SERVICE TECHNICAL INFORMATION

ONE POINT REPAIR

REF. NO. : SI-95-047

- MODEL : XG-990 (SX-N990)
 SUBJECT : Prevention of tweeter short recurrence
 CONTENTS : When there is a short in the speaker tweeter, perform the remedy described below.
 When the tweeter shorts, the protection circuit of the unit operates to turn the power off.
 REMEDY : Along with replacing the tweeter, also add the condenser listed below when repairing the relevant products.

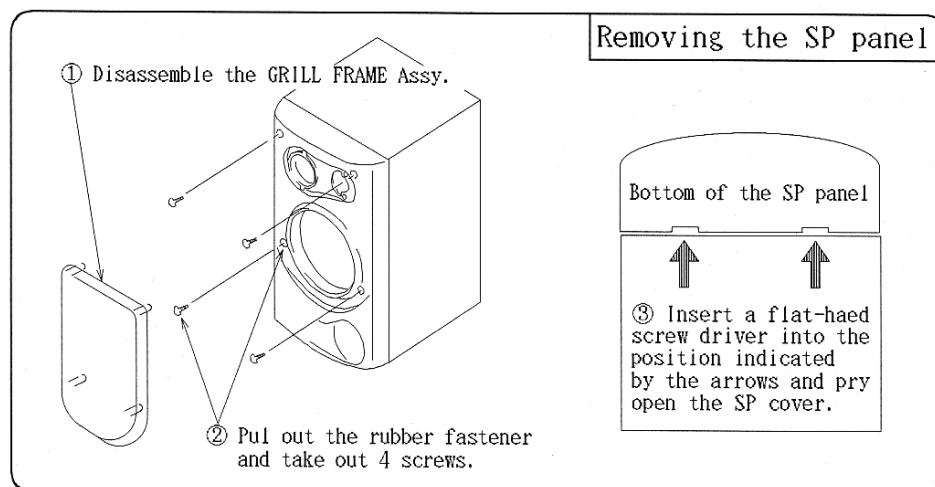
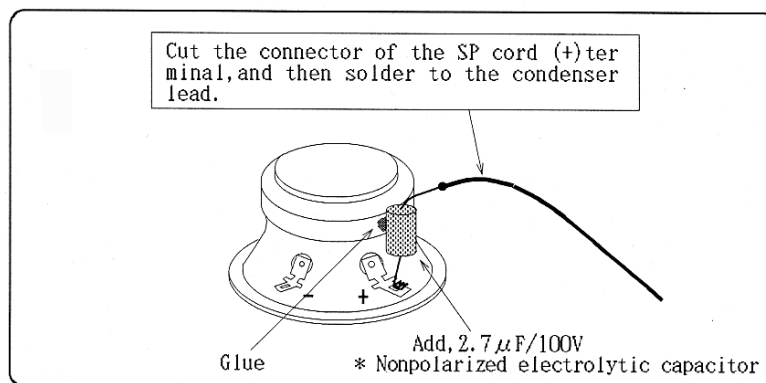
- Method**
- 1) Remove the speaker panel and replace the tweeter.
 - 2) As shown in the figure below, add a BP condenser (2.7 μ F/100V) in series to the (+) terminal of the replaced tweeter.
 - 3) Glue the added condenser to the tweeter.

Part No.	Part Name	Ref. No.
83-135-627-010	BP 2.7 μ F / 100V	---
82-NS6-601-010	Speaker tweeter	---
